AA618.422

GENERAL ENGINEERING REQUIREMENTS
FOR
INSTALLATION OF
LEAD LINED WOOD TANK STORAGE BATTERIES
POWER SYSTEMS

FIG. 4 - ARRANGEMENT OF BUS BAR SUPPORTS

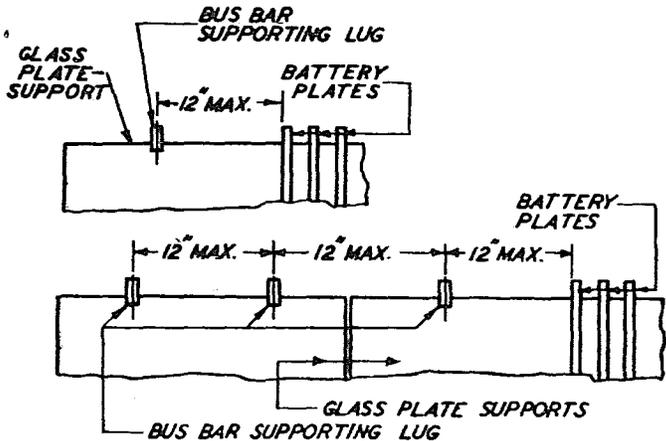
FIGURES 4 AND 5, PAGES 5 AND 6

CHANGE: Figures 4 and 5 as follows:

BUS BAR SUPPORTING LUGS FOR PARTIALLY FILLED CELLS

FIG. 6 - STYLE "C" AUTOMATIC WATER FILLER

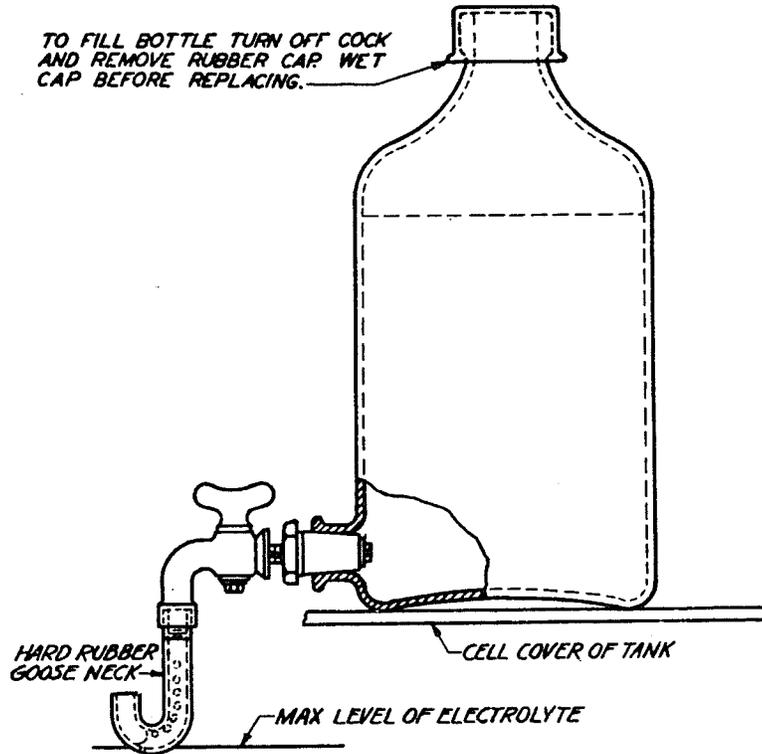
FIGURE 6, PAGE 7

CHANGE: Figure 6 as follows:
